**RE: 3505 Campbell Farm Lane NW  
Grading & Drainage Plan  
Engineer's Stamp Date: 02/12/24  
Hydrology File: G13D045**

## DRAINAGE AND TRANSPORTATION INFORMATION SHEET (DTIS)

Project Title: North Valley House Hydrology File # G13D045

GRADING & DRAINAGE PLAN

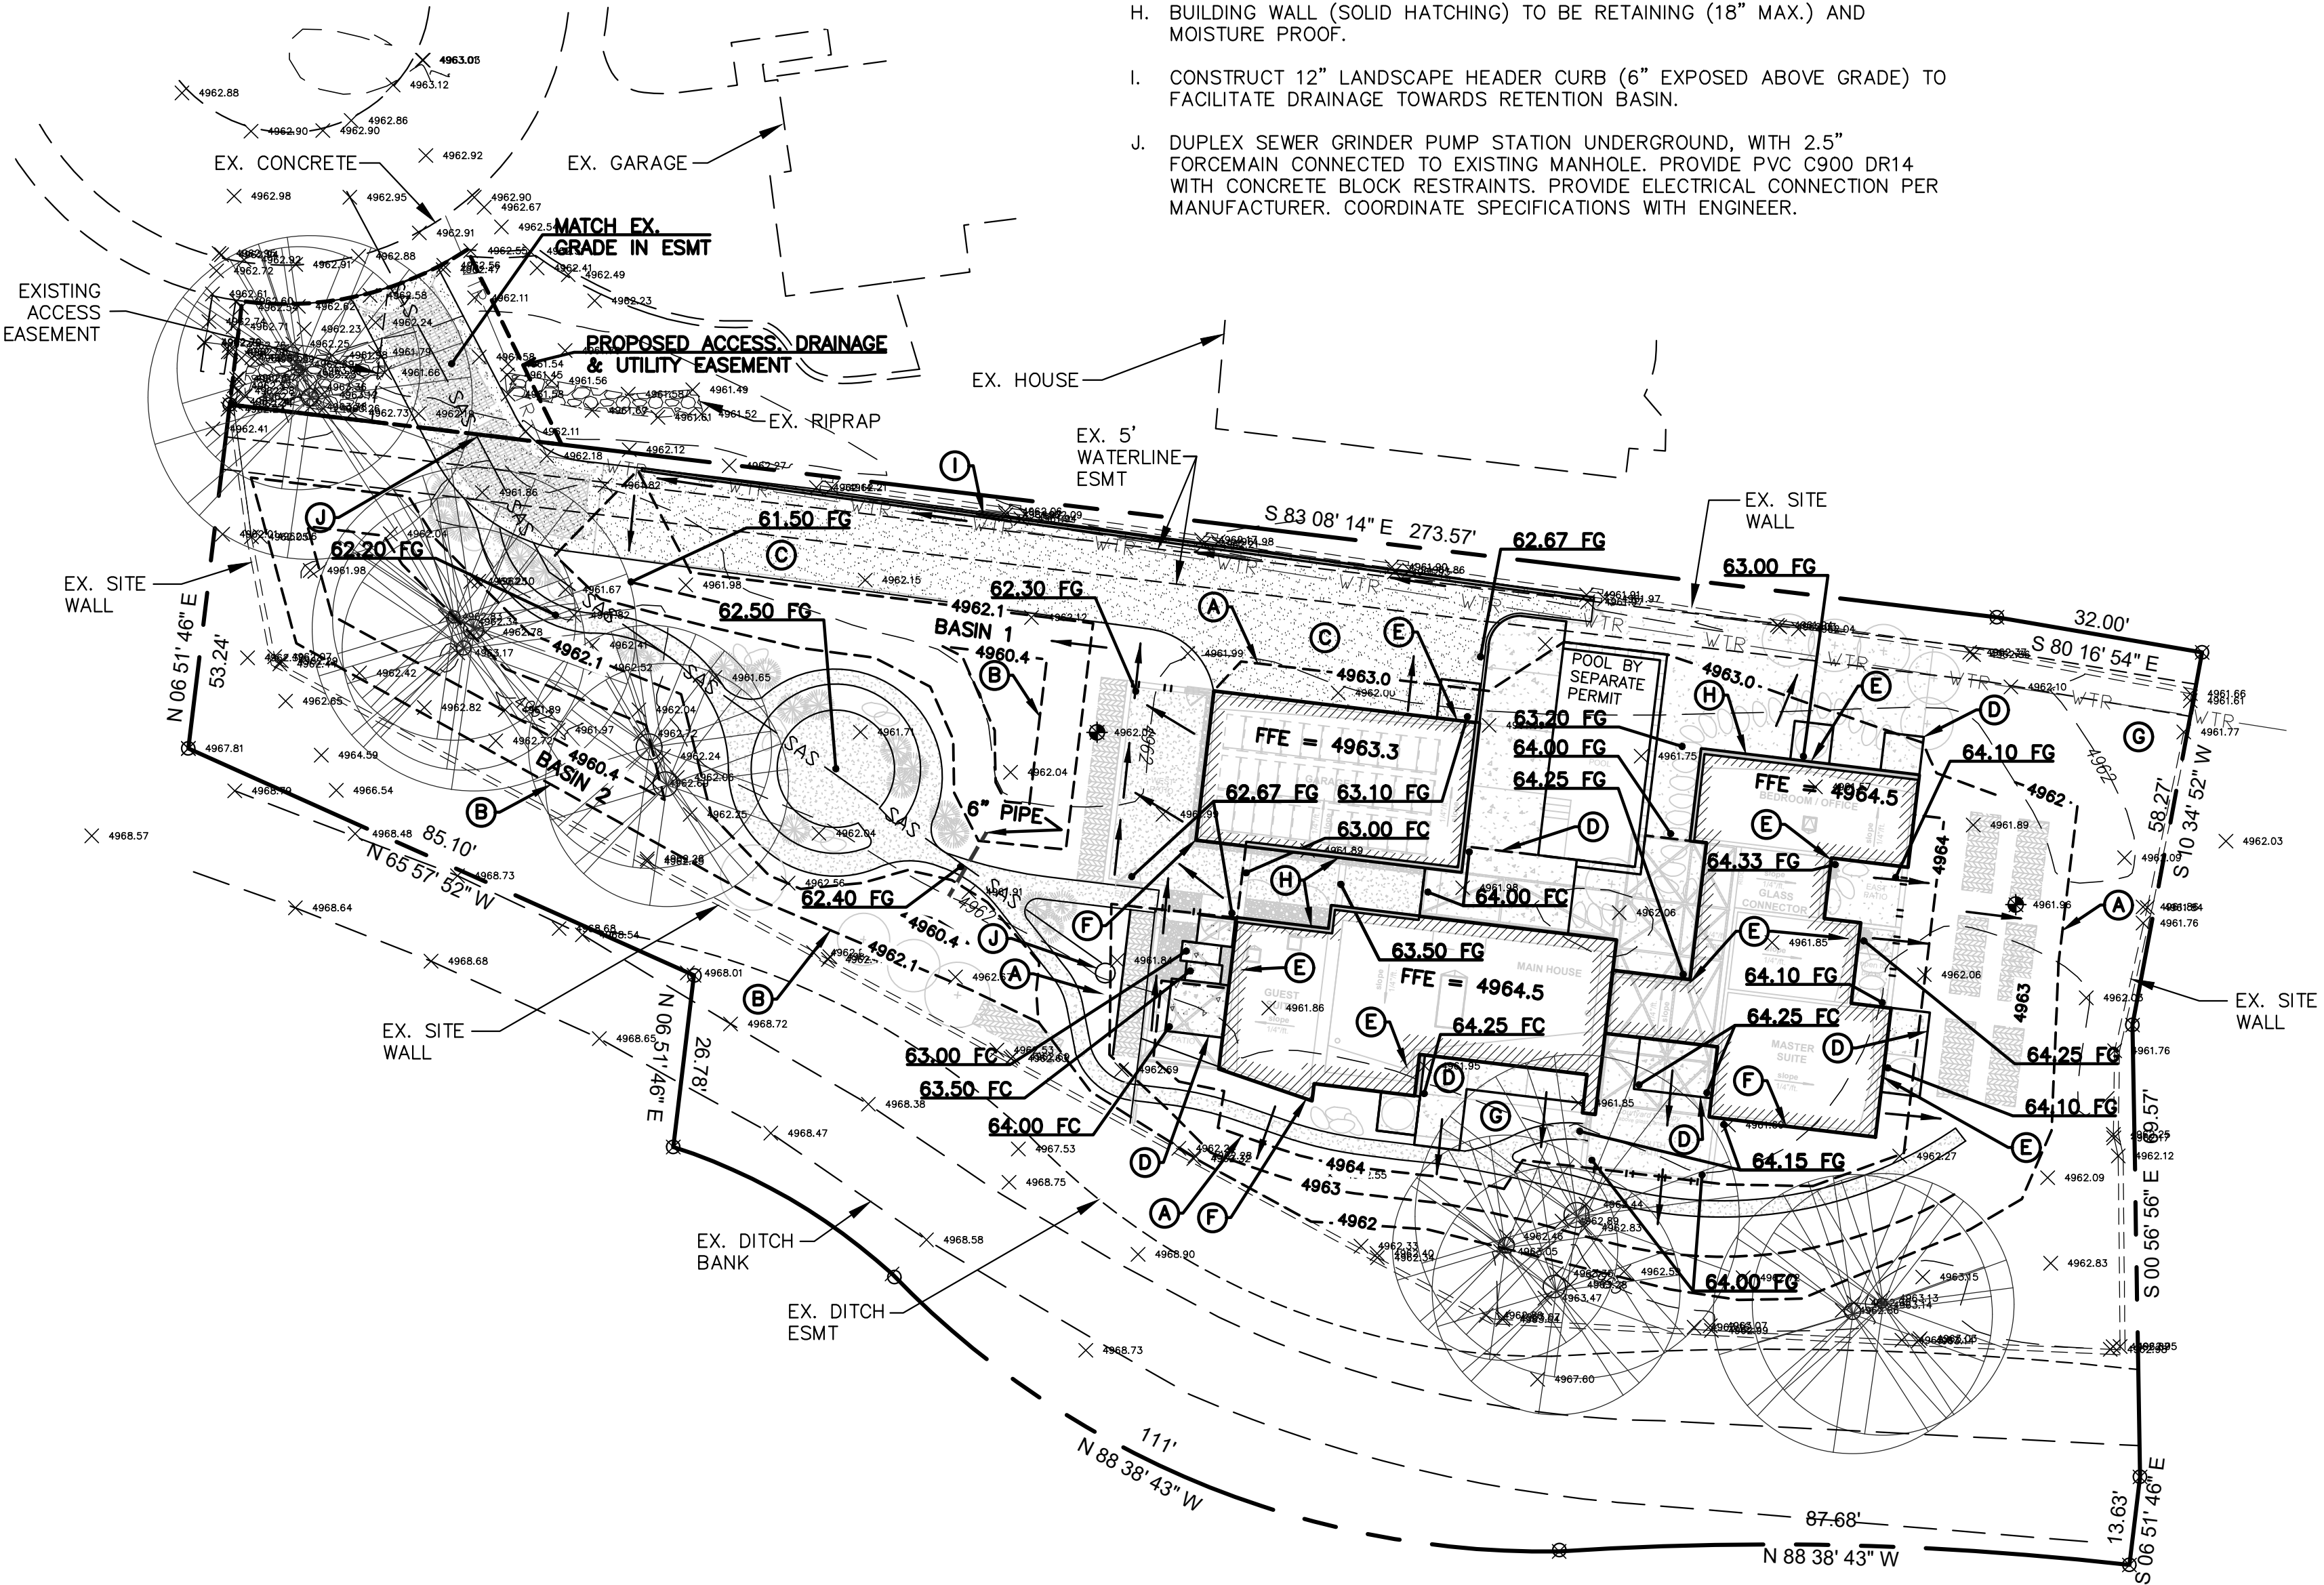
Based upon the information provided in your submittal received 03/05/2024, the Grading & Drainage Plan is approved for Grading Permit (earthwork can get started for the earth pad on the house and retention ponds).

1. Once the grading is complete, a pad certification (meaning that the earthwork and retaining walls are complete) will be required. Please include a site photo with the submittal. Also, at the time of pad certification approval, Hydrology will concurrently approve the Grading & Drainage Plan for Building Permit.
